MTS Exhibit 2

MEMORANDUM

Subject: Update of Current Knowledge Regarding the State of Integrity of OCNGS Drywell Liner and Comments Pertaining to Aging Management Thereof

Figure 2

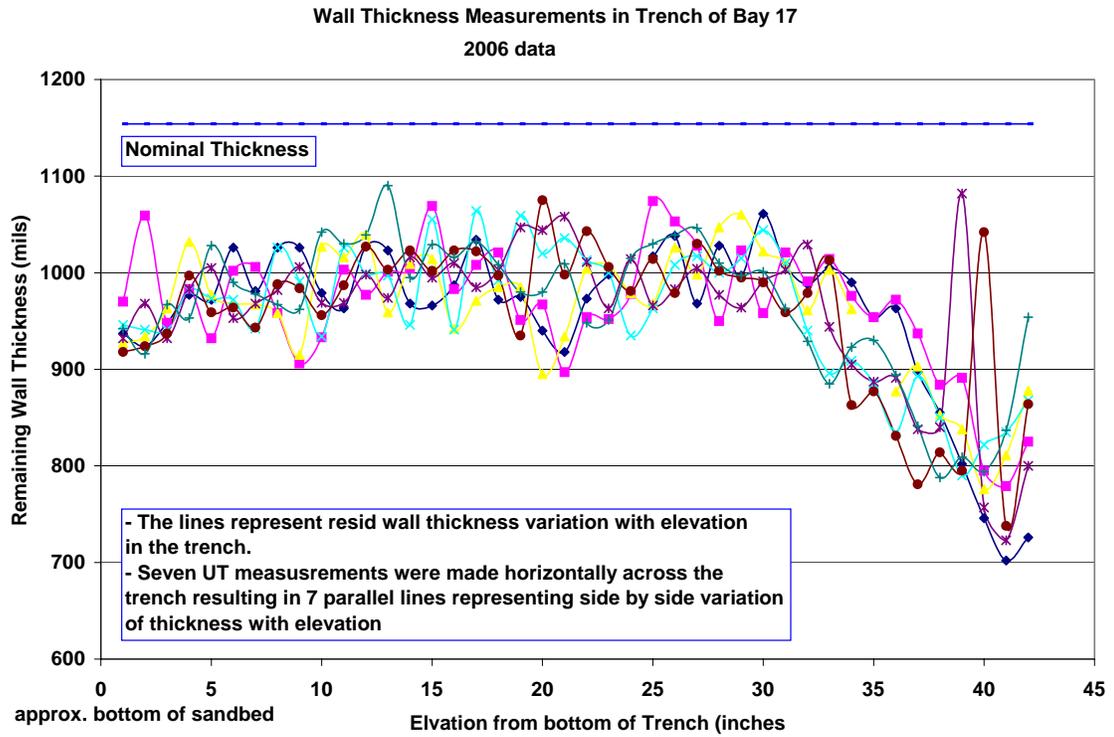
We take issue with this statement. In support of this contention, an effort was made to show graphically the remaining wall thickness observed in all of these various locations. Thus Figure 2 shows, by way of example, the remaining wall thickness from the 2006 UT measurements made with the help of 6 by 6 inch grids as a function of elevation in the **trench of Bay 17**. It is understood, as is described in Ref. 3 that 6 such grids were placed one on top of the other in the trench in order to capture the corrosion from the bottom to the top of the sandbed. Hence, if the bottom of the trench had the elevation about 9 feet, then the top of the 6 grids would have had an elevation of about 12 feet, which according to Figure 1 corresponds to the top of

the sandbed and is at least 9 inches higher than the top of the grid used for UT measurements from the inside. (Note, none of these elevations is terribly accurate, however, the top of the trench measurements were definitely lower (deeper pits) by a good margin than the inside grid measurements). Figure 2 plots all individual 2006 measurements from the trench in bay 17. The 6 traces represent the variation of the wall thickness in the horizontal direction while the traces themselves extend from the bottom of the trench (left hand side) to the top of the trench (right hand side). The undulations of the 6 traces, which are at times (at the same elevation) in synch and at other times out of phase clearly depict the nature of the “golf ball type” surface described in AmerGen literature (Ref. 1 pg. 4). Where the undulations are in synch one can estimate that the extent of the pit at that location extends over an area larger than just one inch in diameter³⁾. It should also be noted that the average amplitude of the undulations in Fig. 2 are of the order of 0.1 inch, i.e. the roughness of the surface at this point is only of that order of magnitude. AmerGen estimated the “roughness” of the surface to be rather of the order of 0.2 inches (Ref. 5 pg. 5).

The most striking observation is that the corrosion is most severe at the top, almost uniform in severity over most of the depth of the sandbed and again somewhat more severe at the very bottom. **In other words, one sees already in this presentation that it would be difficult to single out one small area by means of a 6 by 6 inch grid and claim it to be representative of the corrosion having occurred in the sandbed area.**

increasing depth and very likely uneven water content as well. This inhomogeneity is illustrated in Figure 2, where one can see greater corrosion attack toward the top of the sandbed. Similarly, the data show that in Bay 1 the corrosion below the ventpipe occurred more or less in a band of increased corrosion. This band appears to be about 6 to 7 feet long and perhaps a foot wide, although the lowest residual wall thickness (0.669) is found much deeper in the sandbed (Ref. 3). These data shown numerous in various discussions and appendices clearly demonstrate how difficult it is to assess the extent of the damaged areas as is necessary for comparison with the integrity criteria. For instance, the data gathered in Bay 1 in 2006 (and previous years) represent but a small fraction of the overall drywell liner surface exposed to the sandbed environment, and no amount of statistics can predict the pit distribution seen in Bay 1 (Fig. 5). Furthermore, again, the measurements which assess the corrosion in Bay 1 are all point measurements, and one has no way of assessing whether the pits are as local as the representation suggests or whether in fact the thin areas extend from one measurement to the next. I believe that when assessing the extent of severe corrosion, reviewers should assume that the measured points connect unless other measurements show this not to be the case.

Figure 3

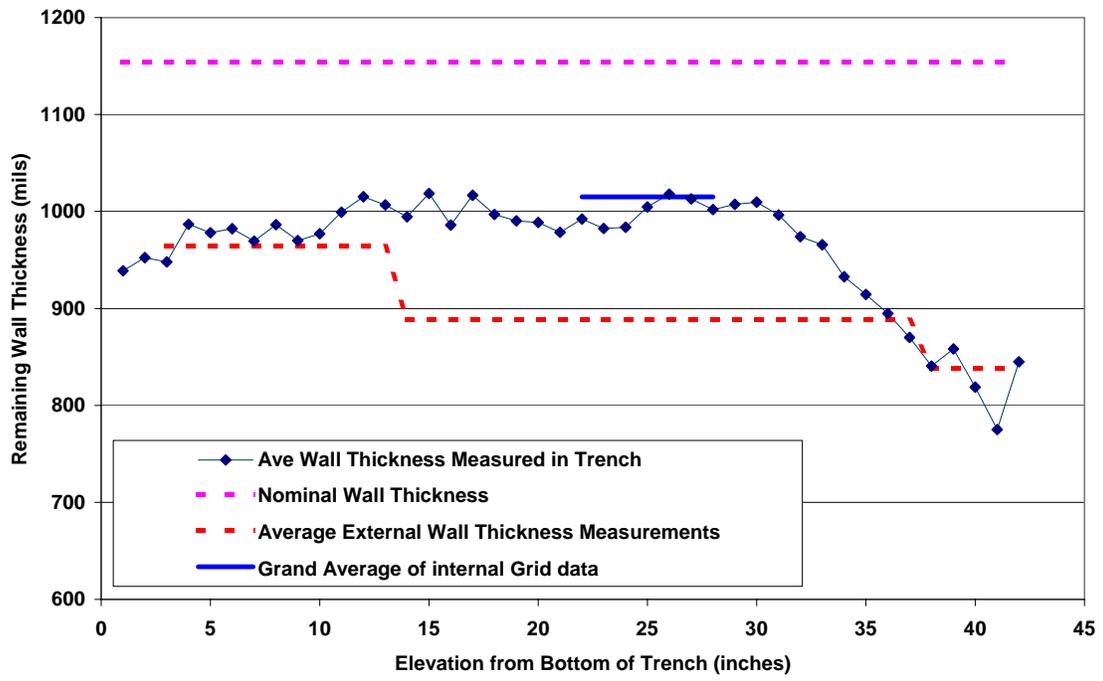
In Figure 3 an effort is being made to compare the average remaining wall thickness from trench measurements (averaged over the horizontal direction) with the average of the 6 by 6 grid measurement from the inside and the direct UT measurements from the outside. Also graphed in this figure are the averages of the outside measurements for the three zones for which data are reported (Ref. 5). What one can see is that the averages for the grid and the trench data overlap quite well at the same elevation. However, the average outside measurements are significantly lower at comparable elevations.⁴⁾ This is probably because the choice of location for the external measurements was deliberately biased towards thin spots.

Figure 4

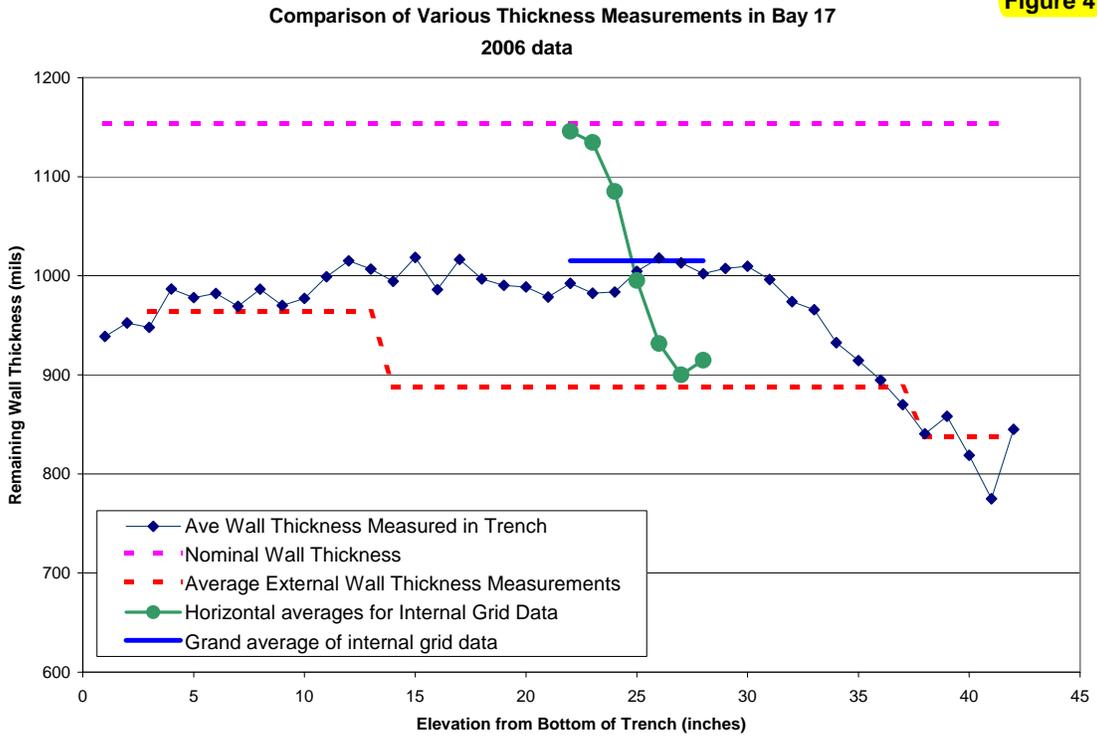
Finally in Figure 4 we see the spread of the 6 by 6 inch inside grid measurements superimposed on the averages of the other measurements.

Conclusion: What the superposition of the UT measurements in Bay 17 demonstrates is that wall loss ranges from zero to 33 percent, however, only the trench and outside measurements come close to represent the most severe corrosion at the highest elevations. The inside grid measurements give a distorted picture. It should also be remembered that the grid measurements at the inside curb cutout as well as those in the trench are only 6 inches wide. One

Figure 5

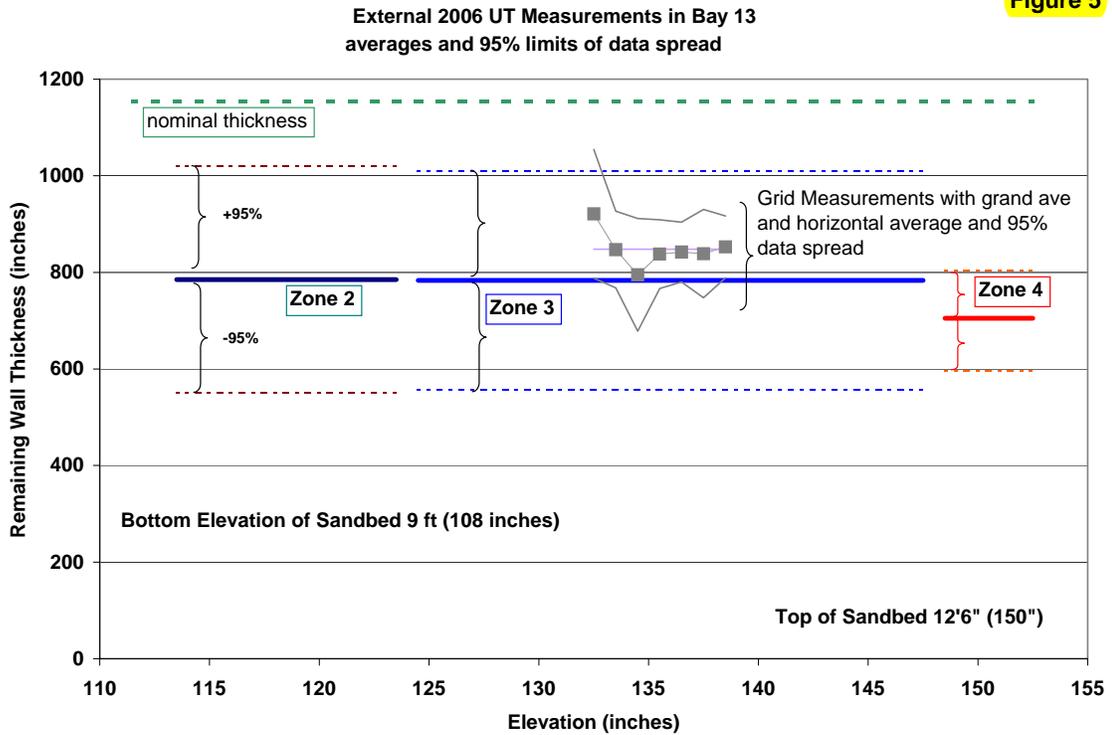
Figure 5 shows an analysis of the available 2006 data for Bay 13. Bay 13 is probably the second worst corroded bay apart from Bay 1. The averages for the external measurements for each zone are fairly similar, as are the 95% limits for the data spread. There is a 95% percent probability for the deepest penetration to be of the order of 48% of the original wall thickness. The superposition of the internal grid data shows a higher average and a narrower distribution of the data spread. Again one recognizes that the internal 6 by 6 inch grid measurements do not represent the worst corrosion degradation.

Figure 6

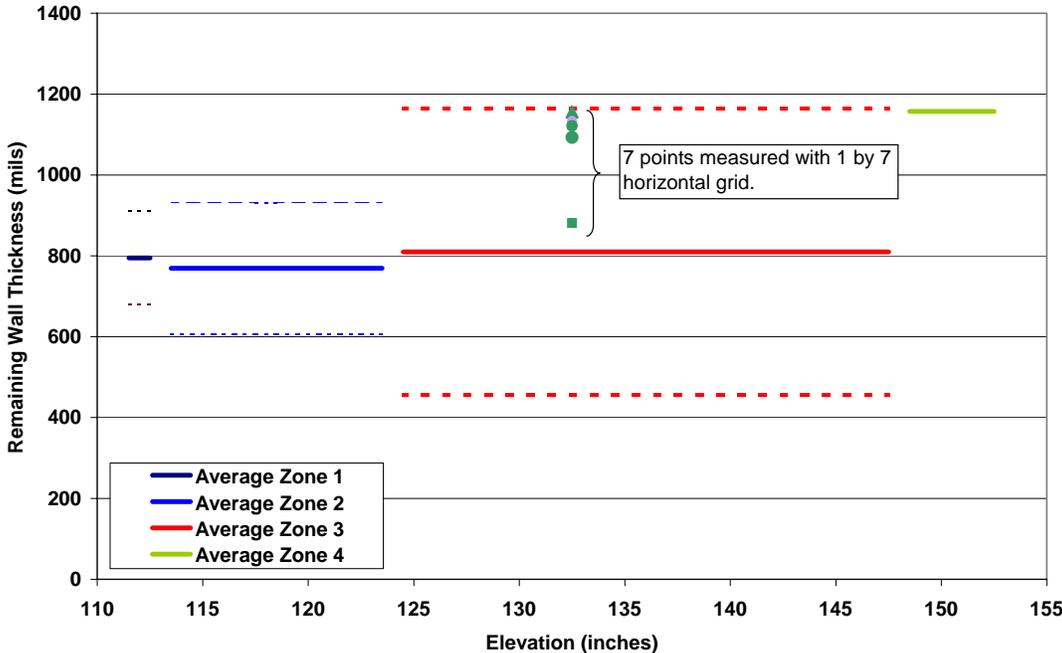
Finally in Figure 6 we show the distribution of the external measurements for Bay 1. One observes that the 95% lower limit of the data spread is around 40% of the original wall thickness, or indeed at a remaining wall thickness of 450 mils, which is 0.04 inches below the required sandbed thickness for the Design Pressure and Temperature. Because the external sampling in Bay 1 was designed to capture the thinnest points, this is a conservative estimate of the minimum wall thickness. However, given the need for a very high degree of confidence that the drywell shell is ready to withstand accident pressures and the uncertainty created by the sparse data set, I believe that a conservative approach is required in this case.

Figure 7

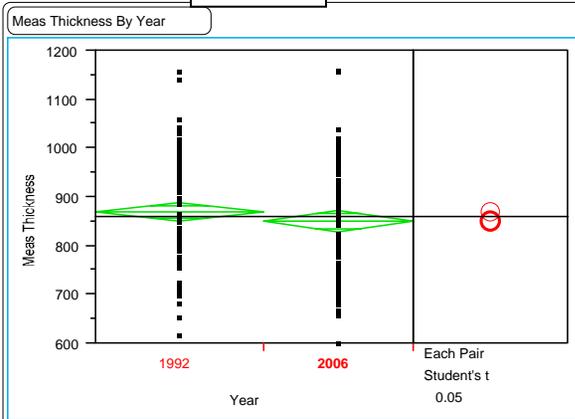
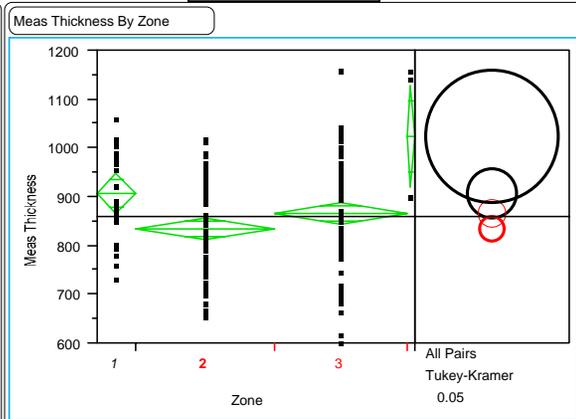
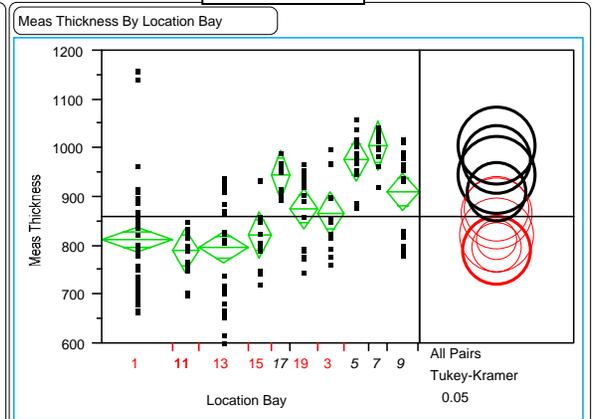
It was found that there is no significant effect of the time (Fig.7a). While there is a decrease of 19 mils between 1992 and 2006, this difference is not statistically

significant within the variability of the data. The differences between the zones, however are significant. Zone 2 is by far the most corrosive zone. When the bays are compared, one finds as expected that some bays have experienced little corrosion in contrast to others. The importance of these observations is obvious: they point again to the fact that the intensity of corrosion is a clear function of elevation and bay. Hence, averaging data and generalization may lead to doubtful conclusions.

Figure 7a: Comparison between measurements in 1992 and 2006 show no significant difference. The means from 1992 and 2006 show a bias of 0.018 inches, but the bias is statistically not significant despite of the many data points. Fig. 7b: The comparison between the “zones” (elevations) is significant. Zones 1 is significantly different from zones 2 and 3. For zone 4 there are not enough data for statistical significance. Fig. 7c: Some bays, red ones, are significantly different from the black ones.

Figure 8: External UT Measurements in Bay 15

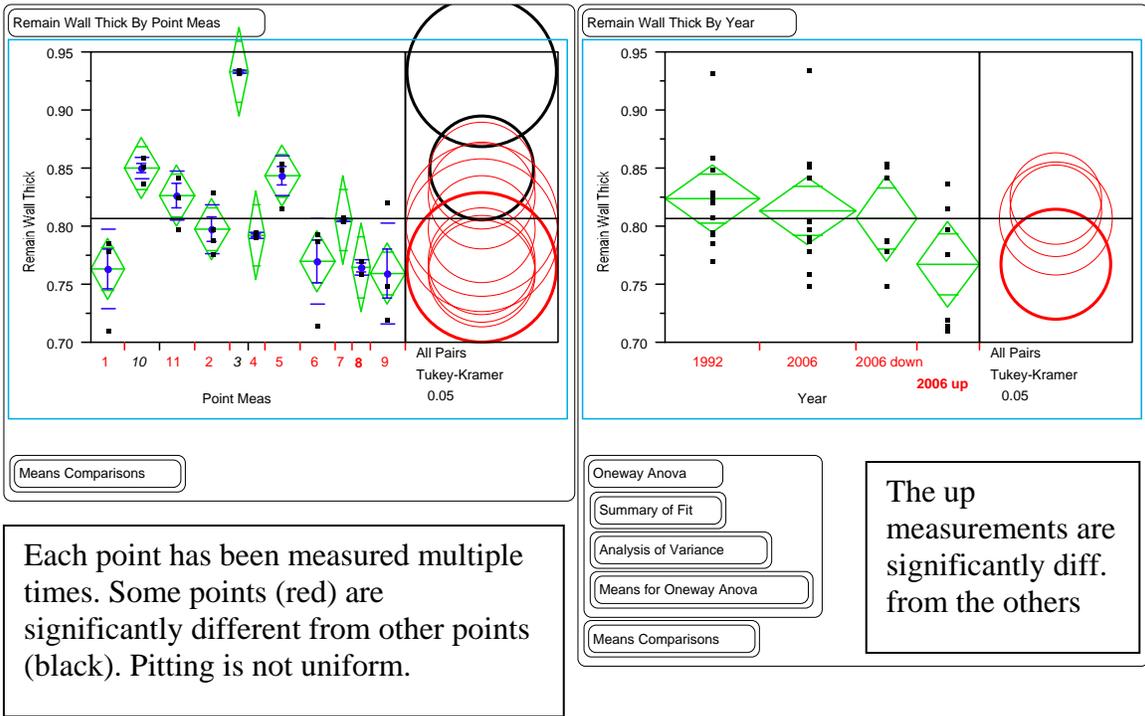
In 2006 the validity of some of the external UT measurements was explored by measuring around the nominal original locations. These data were statistically evaluated in Figures 8, 9, 10 for Bays 15, 1 and Bay 19. The additional data collected in Bays 19 and 15 had been identified as “up” or “down”, hence additional data sets identified as 2006 up and 2006 down were compared with the original 2006 data. It turns out for Bay 19 for instance that the UT penetrations identified as 2006 up were significantly lower than the measurements of 1992 with a probability of better than 95%. The difference between the 1992 and 2006 up data is 0.1 inch. Similarly for Bay 15 one finds that the 2006 up data are significantly lower than the original 1992 data by about 0.06 inches, although this difference is not significant at the 5% level. For Bay 1 there is practically no difference between the 2006 and the 1992 data sets, because of the two or three measurements in the non-corroded areas. Summarizing these results in Table 1, one finds that the lower 95% confidence limits for Bays 1, 15 are marginally within the 0.736-inch limit. Since one does not know exactly how extensive the “cancer of corrosion” in the sand bed area really is, it is very difficult to put this interpretation in perspective with the assessments made by AmerGen relative to areal criteria for thinned areas (see discussion below).

Each point has been measured multiple times. Some points (red) are significantly different from other points (black). Pitting is not uniform.

Figure 10: External UT measurements in Bay 19

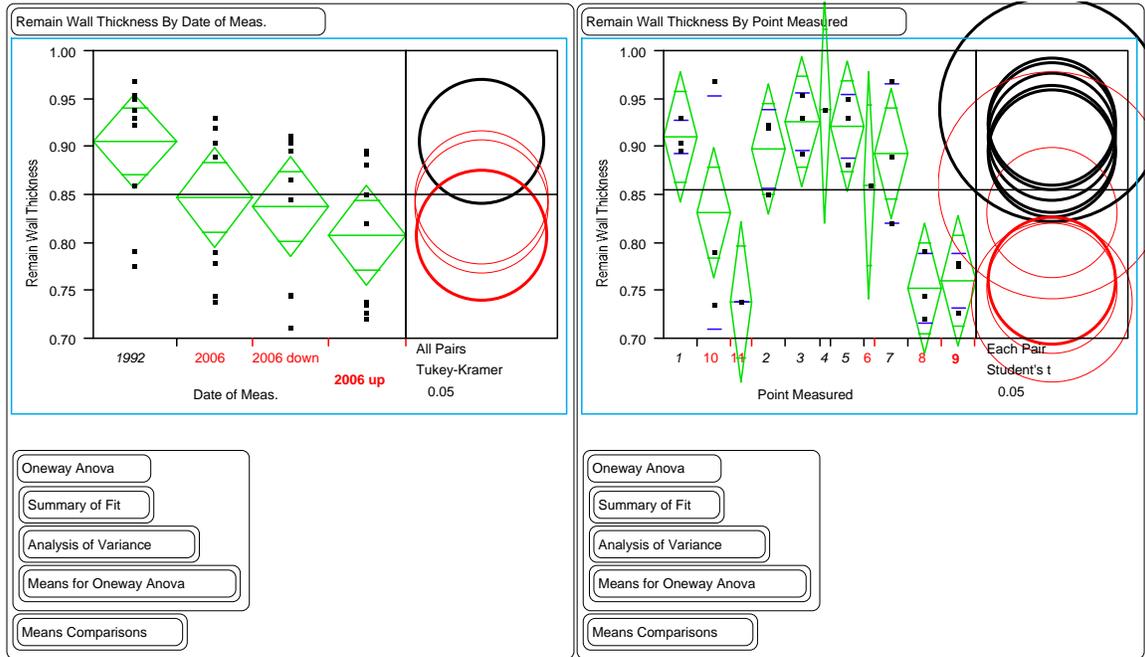
Again one finds that the “up” measurements are significantly lower from the 1992 measurements.
